Access Compliance Report

Public Rights-of-Way

Intersection ID: 18040	Main Street: EAGLEWIND_DR	Cross Street: PINEY_GROVE_RD	Location: SE
ADA ID: 5C08241AE2B8	Ramp Type: PerpDiag	Initial Pass/Fail: Fail	Overall Compliance: No
Severity Score: 25			
Codes/Mitigation Info/Possible Solution		Field Measurements/Component Compliance

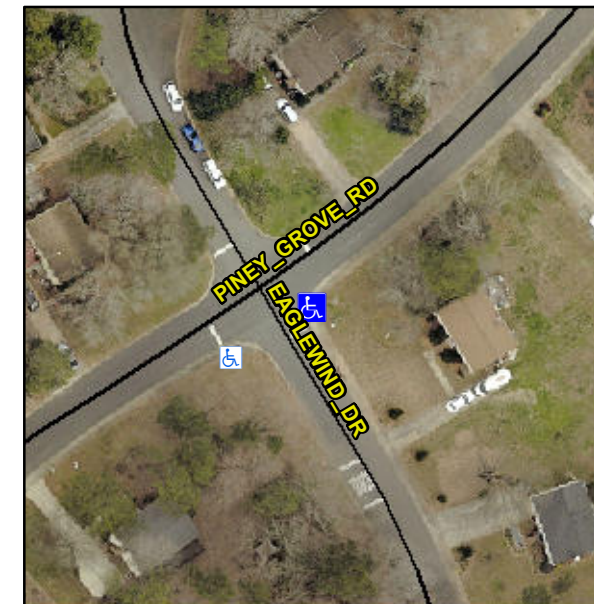
Not Found, R304.5.3

Compliance	Description	Data	Compliance	Description	Data
N/A	Ramp Length (in)	45.0	Yes	Ramp Slope (%)	5.8
Yes	Ramp Width (in)	48.0	No	Ramp XSlope (%)	7.1
N/A	Flare Type LT	N/A	N/A	Flare Type RT	N/A
N/A	Flare Slope LT (%)	N/A	N/A	Flare Slope RT (%)	N/A
N/A	Flare Traversable LT?	N/A	N/A	Flare Traversable RT?	N/A
N/A	Landing Length (in)	N/A	N/A	DWS Provided?	N/A
N/A	Landing Width (in)	N/A	N/A	DWS Contrast?	N/A
N/A	Landing Slope (%)	N/A	N/A	DWS Length (in)	N/A
N/A	Landing X Slope (%)	N/A	N/A	DWS Full Width?	N/A
N/A	Landing Curb? (Y/N)	N/A	N/A	DWS Offset (in)	N/A
N/A	Shared Landing?	N/A			
N/A	Gutter Ponding?	N/A	N/A	Gutter Slope (%)	N/A
N/A	Gutter Lip Ht (in)	N/A	N/A	Gutter X Slope (%)	N/A
N/A	Painted X Walk1?	No	N/A	Painted X Walk2?	No
	X Walk 1 Direction	To NW		X Walk 2 Direction	To SW
N/A	X Walk 1 Width (in)	N/A	N/A	X Walk 2 Width (in)	N/A
	X Walk 1 Slope (%)	1.5		X Walk 2 Slope (%)	0.2
	X Walk 1 X Slope (%)	3.3		X Walk 2 X Slope (%)	0.2

Remove & Replace Curb Ramp With Two New Directional Ramps or Equivalent.
